TECHNICAL MEMORANDUM

To: THE DEPARTMENT OF DEVELOPMENT, CITY OF COLUMBUS
AND THE FRANKLIN COUNTY REGIONAL PLANNING
COMMISSION

Subject: PRINCIPLES OF TRANSPORTATION PLANNING
FOR THE REGIONAL CENTER

REGIONAL CENTER PLAN AND RENEWAL PROGRAM
COLUMBUS, OHIO

POSSIBLE FREEWAY REVISION
LOCATION 1

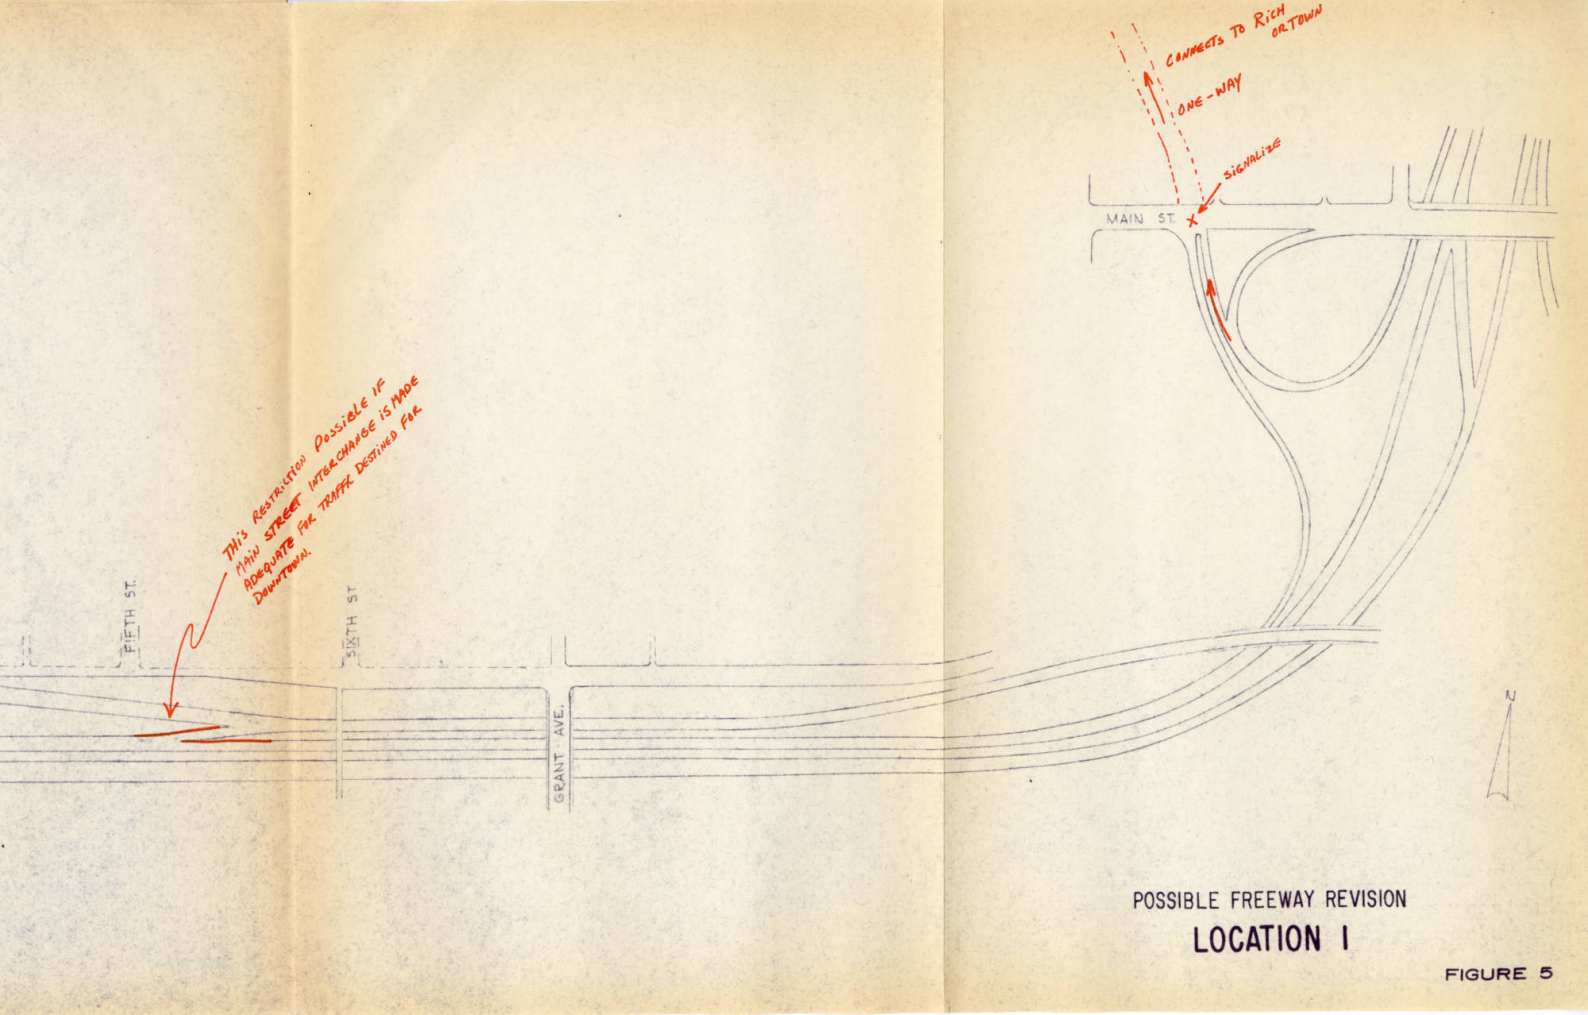
THIS RESTRICTION POSSIBLE IF
 MAIN STREET INTERCHANGE IS MADE
 ADEQUATE FOR TRAFFIC DESTINED FOR
 DOWNTOWN.
